I write in response to Natural England's Deadline 8 submission published on 15<sup>th</sup> March

This included notes on a number of Moisture Balance calculations requested but not received previously.

PDA-002 p274 shows the Fen Edge as found by the archaeologists

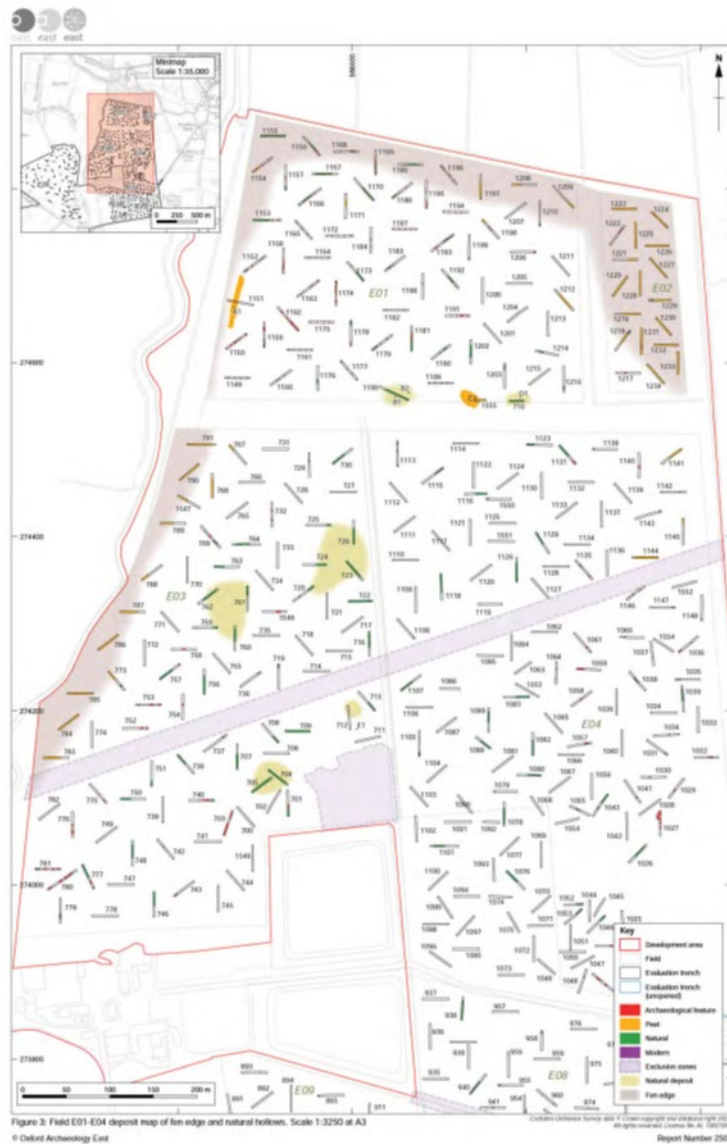
Points are missing over the field (APP 115 p147) which often seem to co-incide with areas where peat deposits were found eg above the farm along the edge of Lee Brook where Fen Edge deposits were found PDA 002 p 274 No explanation has been given for these missing points- whether or not these areas were even investigated by DBSC.

That the DBSC survey found shallow soils and only peat at one point does not tally with the picture painted by the archaeologists who cannot simply dismissed by the applicant as biased
